Minute No. 133
Report – Standing Policy Committee on Property and Development, Heritage and Downtown Development – January 6, 2020

Item No. 4 Subdivision and Rezoning – 307 and 315 Talbot Avenue (Elmwood-East Kildonan Ward) File DASZ 34/2019 [c/r DAV 184885/2019D]

Title: DASZ 34/2019 – 307 and 315 Talbot Ave.

Issue: Proposed Plan of Subdivision and Rezoning to Accommodate a Proposed Multi-Family Dwelling and a Proposed Restaurant

SCHEDULE "A" OF FILE DASZ 34/2019, East Kildonan – Transcona Community Committee, dated November 18, 2019

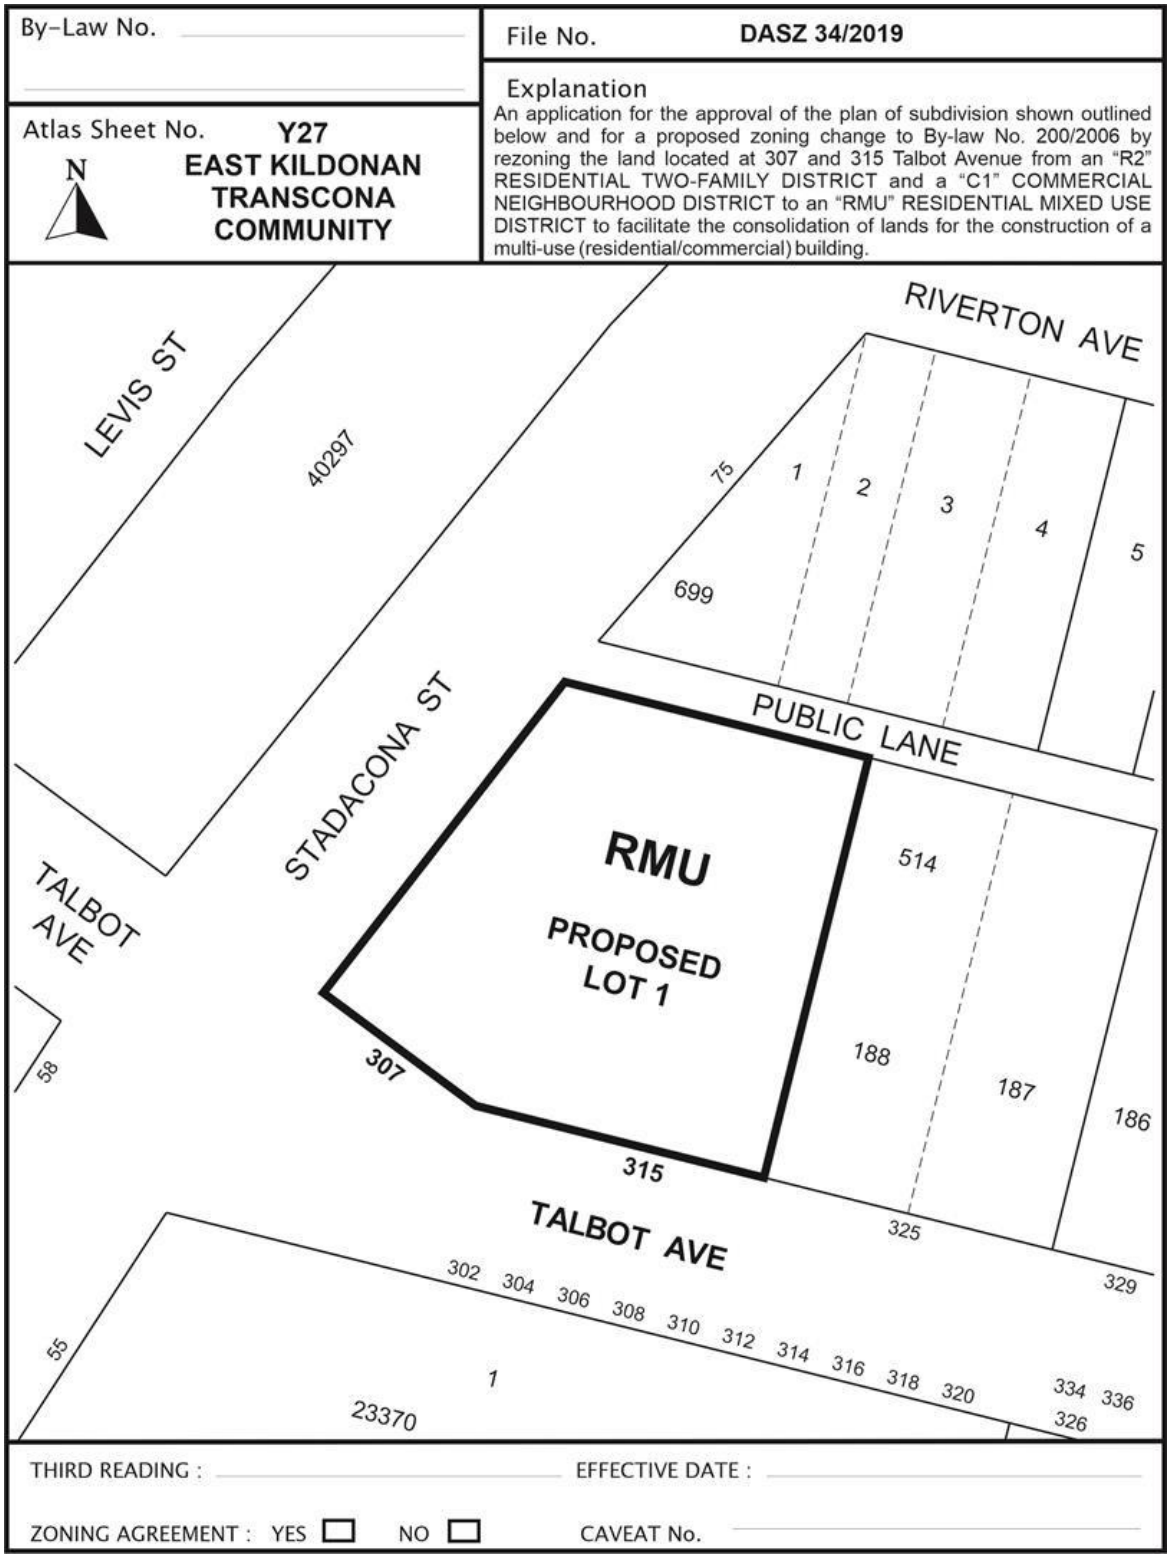
- The proposed plan of subdivision would have to show the public lane right-of-way widening (4.5 feet);
- The site plan would have to show the depth of the parking spaces as 21 feet, a rear yard of 24 feet and a front yard (to the proposed addition) of two feet; and
- The south elevation of the proposed addition, and the associated floor plan, would have to show at least one ground floor window on the four storey portion facing Talbot Avenue.

A. *That the Developer shall, at no expense to the City, legally open property required for a 1.373 metres (4.5 feet) widening to the existing east-west public lane right-of-way, along the full length of the Planned Area abutting the existing east-west public lane, as determined by and to the satisfaction of the Director of Public Works.*

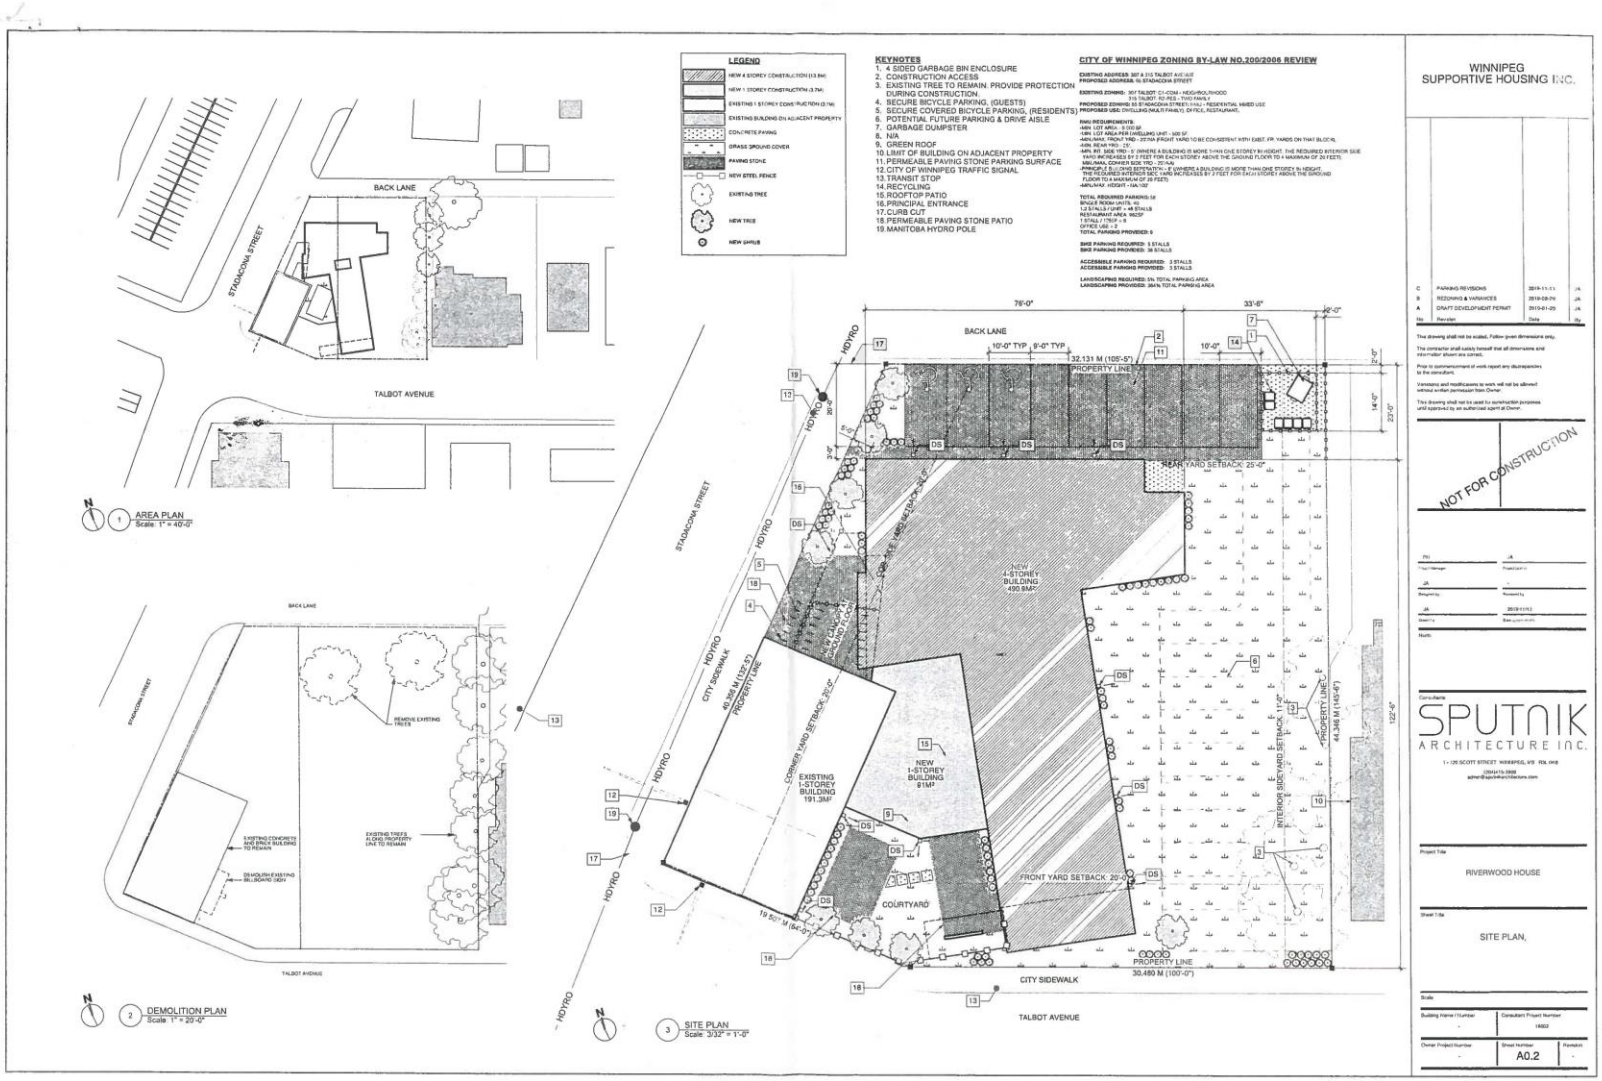
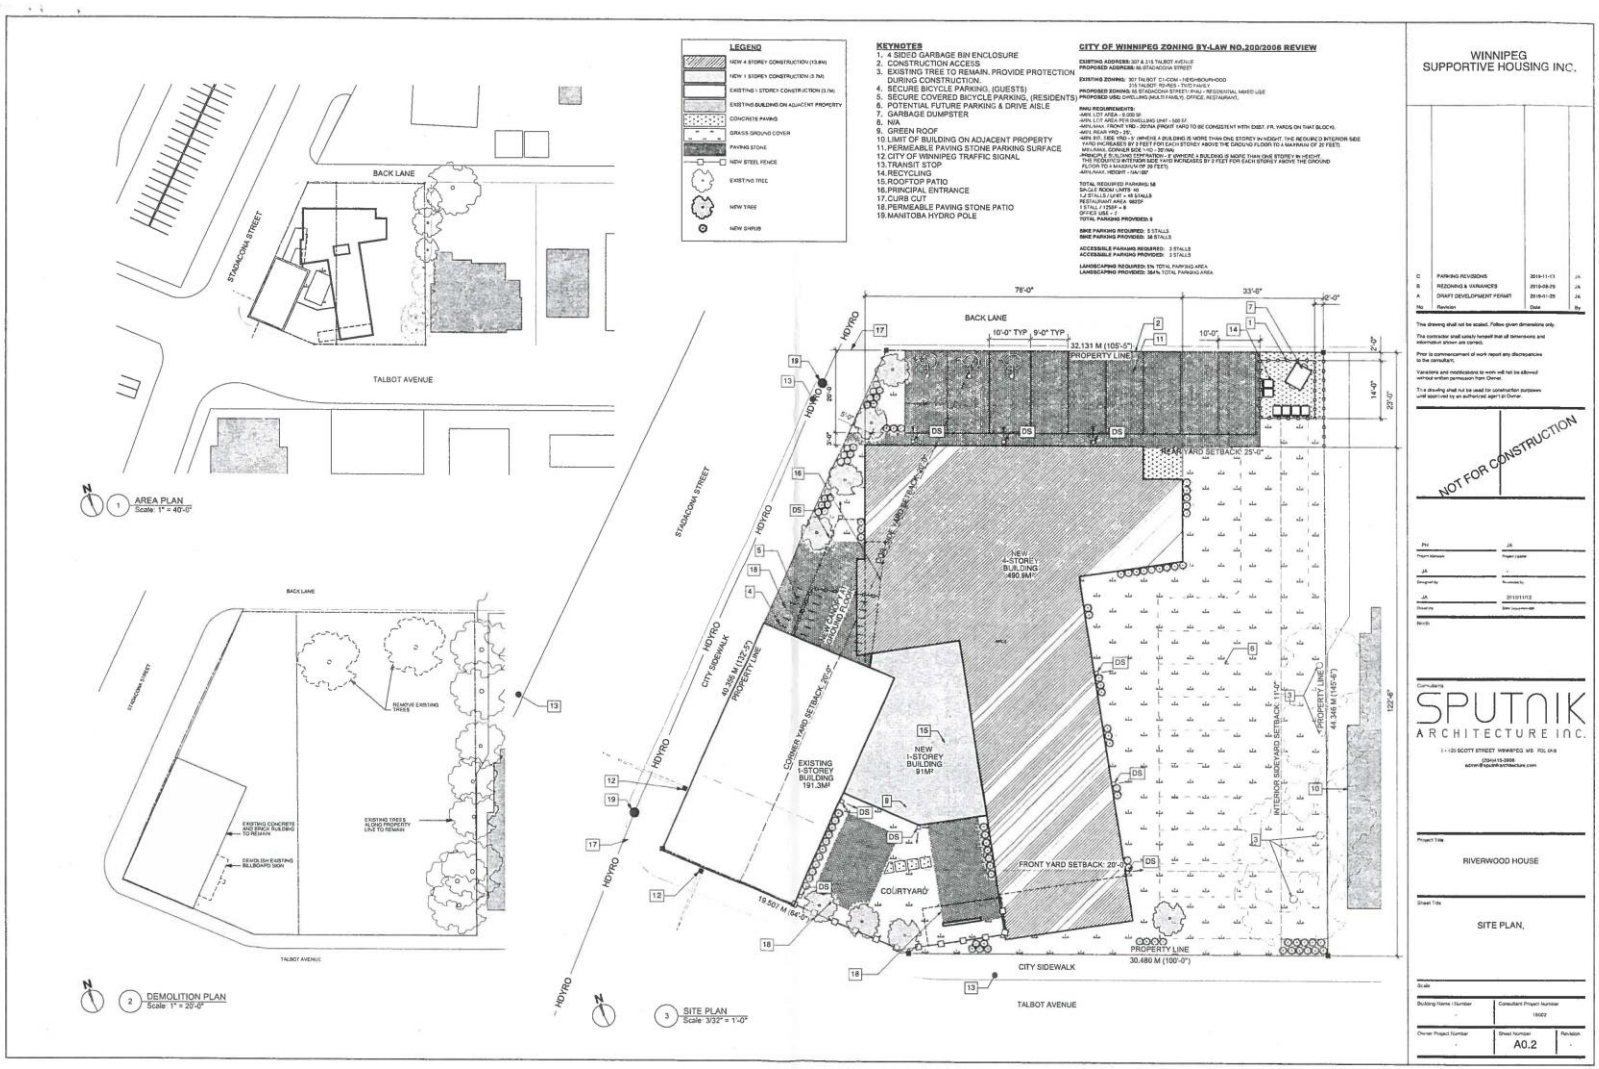
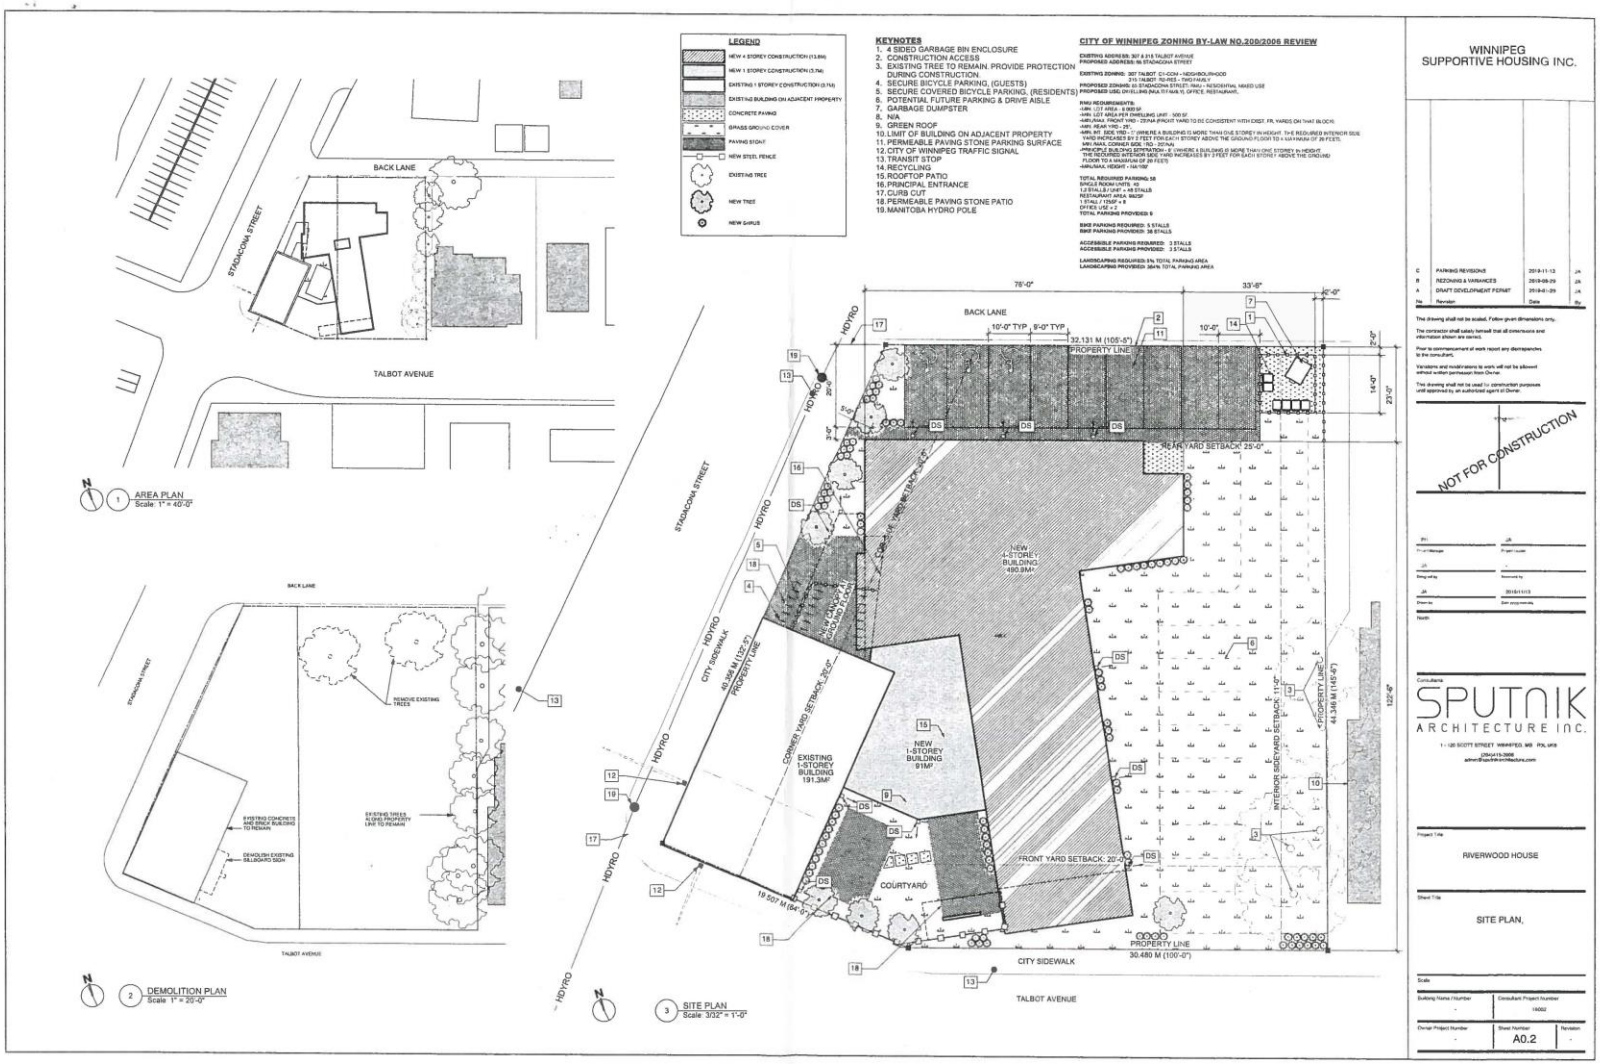
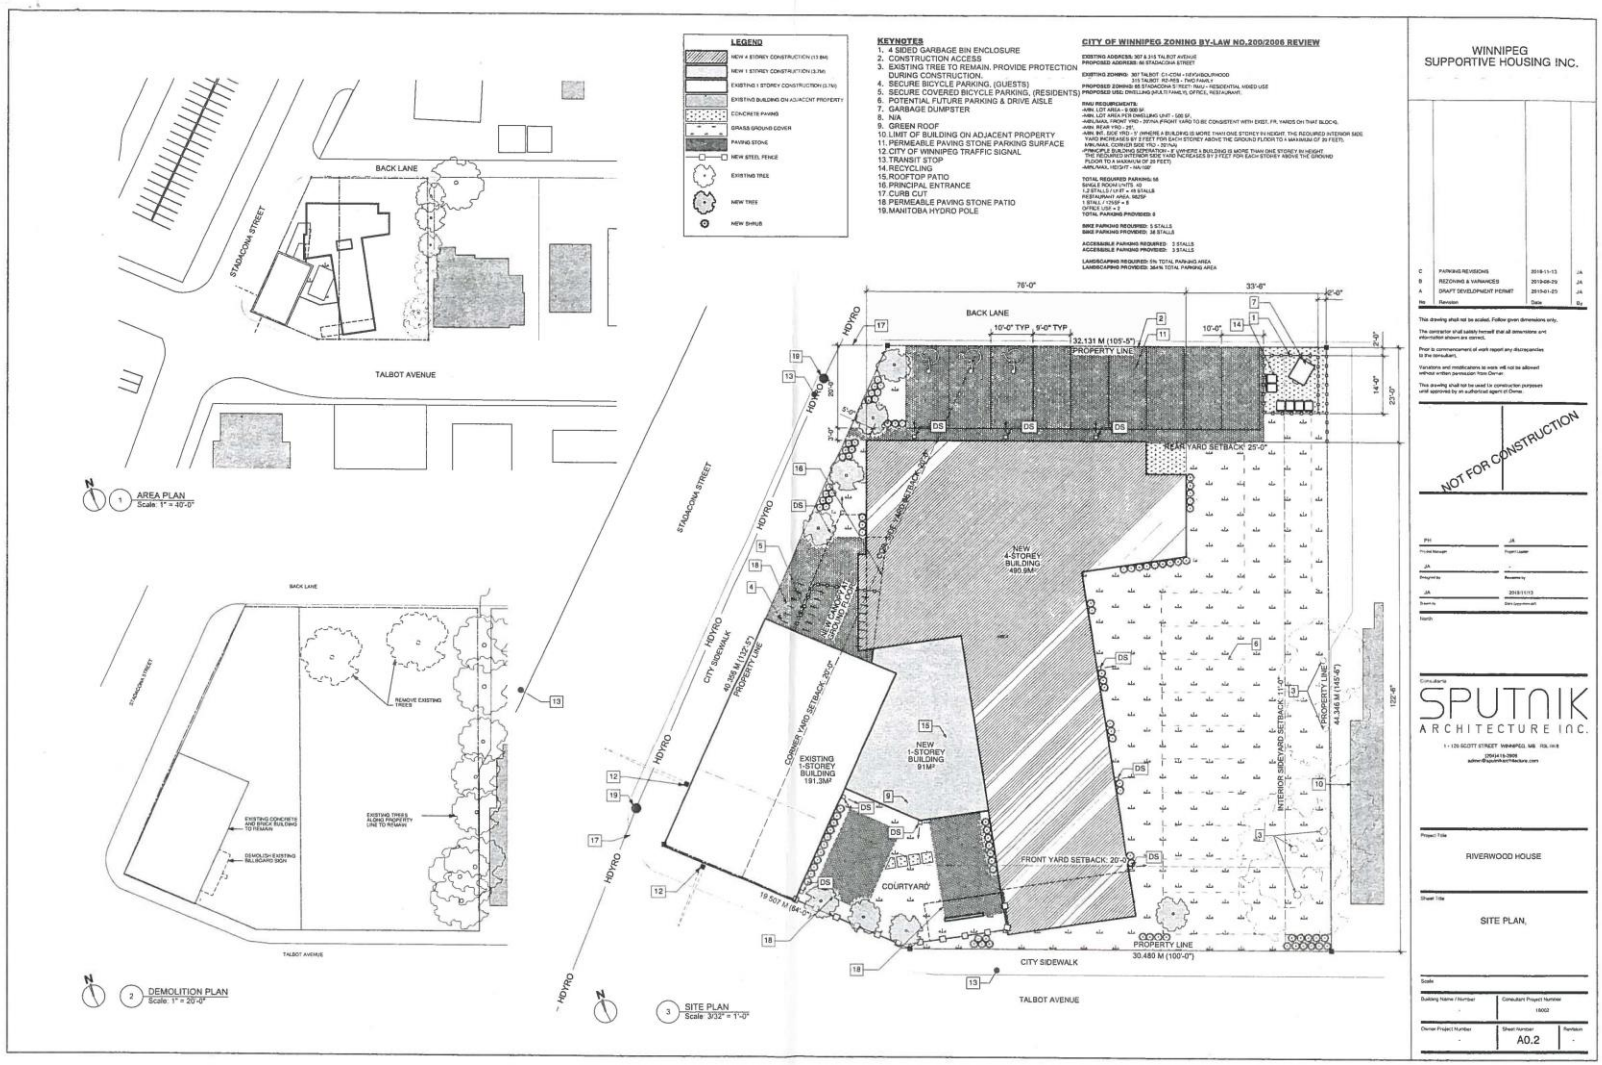
- the Public Works Department requires the northerly 4.5 feet of the site in order to widen the public lane right-of-way immediately north of the site; and
- the Urban Planning Division recommends that the proposed parking spaces be 21 feet in length instead of the proposed 20 feet and instead of the required length of 23 feet.

In order to accommodate the public lane widening and a one foot increase to the length of the proposed parking spaces, without reducing the proposed addition's front yard, the depth of the proposed addition (measured perpendicular to the site's northern limit) would have to be reduced by 5.5 feet (one foot for the longer parking spaces and 4.5 feet for the public lane widening).

The width of the existing public lane right-of-way is only 16 feet and the length of the proposed parking spaces would only be 20 feet. Public Works has indicated that, for the public lane to function properly, the public lane right-of-way has to be widened to 20.5 feet (6.25 metres). For the parking spaces to provide a reasonable level of safety for residents accessing the trunk of their vehicle, and some space for temporary snow storage, the length of the parking spaces should be at least 21 feet. Therefore, if the proposal is not modified accordingly, it would not comply with all of the aformentioned policies. Specifically, the proposal:

Variances are also needed to accommodate the proposed development, including a variance to permit the parking spaces to be 20 feet in length instead of 23 feet. A variance application has been submitted under File DAV 19-184885D. An administrative report on this application has also been submitted. It recommends that the aforementioned parking space variance be approved as-modified to permit a parking space length of 21 feet instead of 23 feet.
